Access Compliance Report

Public Rights-of-Way

Intersection ID: 30497	Main Street: STONES_LANDING_ST	Cross Street: WALKING_STICK_DR	Location: NW
ADA ID: 8E31F3F1DE76	Ramp Type: Perpendicular Diagonal	Initial Pass/Fail: Fail	Overall Compliance: No
			Severity Score: 8.75

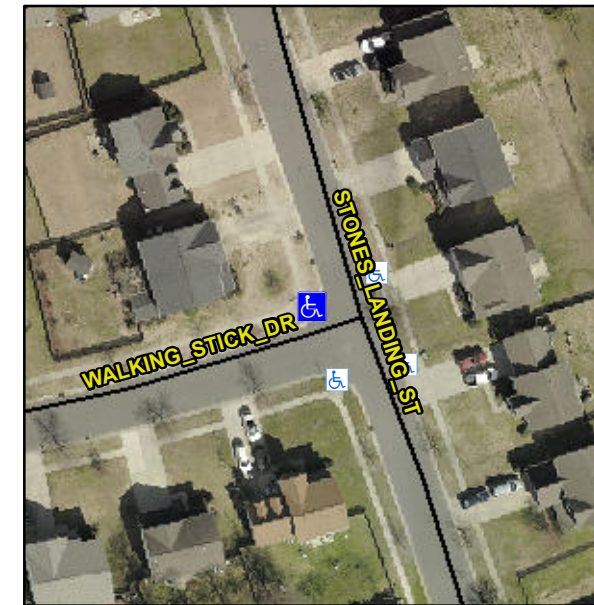
Not Found, R304.5.1

Compliance	Description	Data	Compliance	Description	Data
N/A	Ramp Length (in)	84.0	Yes	Ramp Slope (%)	5.9
No	Ramp Width (in)	44.5	Yes	Ramp XSlope (%)	1.8
N/A	Flare Type LT	N/A	N/A	Flare Type RT	N/A
N/A	Flare Slope LT (%)	N/A	N/A	Flare Slope RT (%)	N/A
N/A	Flare Traversable LT?	N/A	N/A	Flare Traversable RT?	N/A
N/A	Landing Length (in)	N/A	N/A	DWS Provided?	N/A
N/A	Landing Width (in)	N/A	N/A	DWS Contrast?	N/A
N/A	Landing Slope (%)	N/A	N/A	DWS Length (in)	N/A
N/A	Landing X Slope (%)	N/A	N/A	DWS Full Width?	N/A
N/A	Landing Curb? (Y/N)	N/A	N/A	DWS Offset (in)	N/A
N/A	Shared Landing?	N/A			
N/A	Gutter Ponding?	N/A	N/A	Gutter Slope (%)	N/A
N/A	Gutter Lip Ht (in)	N/A	N/A	Gutter X Slope (%)	N/A
N/A	Painted X Walk1?	No	N/A	Painted X Walk2?	No
	X Walk 1 Direction	To S		X Walk 2 Direction	To E
N/A	X Walk 1 Width (in)	N/A	N/A	X Walk 2 Width (in)	N/A
	X Walk 1 Slope (%)	0.9		X Walk 2 Slope (%)	3.9
	X Walk 1 X Slope (%)	0.8		X Walk 2 X Slope (%)	1.5

Remove & Replace Curb Ramp With Two New Directional Ramps or Equivalent.
